**SUBDIVISION VARIANCE REVIEW SHEET****CASE NO.:** C8-2018-0029.0A**PC DATE:** March 12, 2019**SUBDIVISION NAME:** AISD 51<sup>st</sup> Street**AREA:** 11.96 acres**LOT(S):** 1**OWNER/APPLICANT:** AISD**AGENT:** LJA Engineering**ADDRESS OF SUBDIVISION:** 4800 E 51<sup>st</sup> Street**COUNTY:** Travis**WATERSHED:** Fort Branch**JURISDICTION:** Full-Purpose**EXISTING ZONING:** SF-6-NP**NEIGHBORHOOD PLAN:** Pecan Springs/Springdale**PROPOSED LAND USE:** Residential

**AISD - 51st Street**  
**City of Austin, Texas**  
**Travis County, Texas**

SUBJECT: Variance Request AISD 51st Street  
Case Number – C8-2018-0029.0A

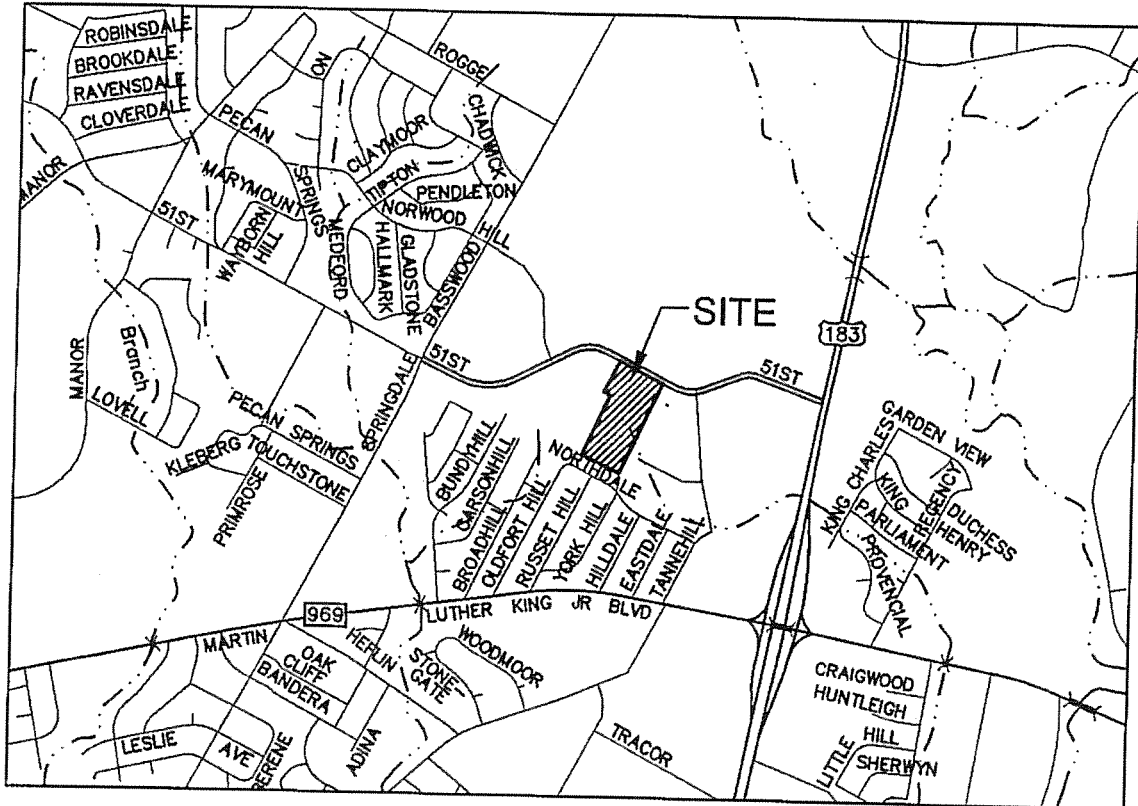
The applicant for the above referenced subdivision is requesting a variance to Title 25 of the Land Development Code (LDC) Section 25-4-151, which requires streets of a new subdivision to be in line with existing streets on adjoining property. The variance is to not extend connections to Connally Lane and Rayburn Lane through the lot.

- Connally Lane and Rayburn Lane are existing local streets which provide access to the single-family residential units to the east.
- Traffic circulation would not be compromised if Connally Lane and Rayburn Lane were not extended because there is another ingress and egress point throughout this subdivision and adjacent subdivisions to right-of-way.
- The applicant is proposing other connections to serve the public via public access easements which stub out at the property to the west and will allow for further connections when that property is brought in for development.

Comments: Development on this large tract of land should incorporate in to the existing housing and not be a separate enclave. By not connecting to Senate Hills this subdivision just becomes another area of gentrification instead of an addition to our community.

- The site shall provide internal drive and sidewalk connections to Rayburn Lane and Connally Lane and extend the internal drives and sidewalks through the property to provide a minimum of two connections/internal drive and sidewalk stub outs to the western property line for future connectivity.
- The internal drive and sidewalk cross-section should meet the following: minimum 28-foot pavement width (FOC-FOC) and minimum 5-foot sidewalks on both sides of all drive aisles.
- The site shall dedicate a minimum 40-foot privately maintained public access easement (PAE) over all proposed internal drives and sidewalks within the site at the time of the site plan application. The width of the PAE may increase to accommodate the transportation facilities identified in the required cross-section.

- Any proposed connection to E 51st Street from the site shall comply with the Transportation Criteria Manual (TCM). A median break and turn lane shall comply with the TCM and be approved by the Austin Transportation Department.
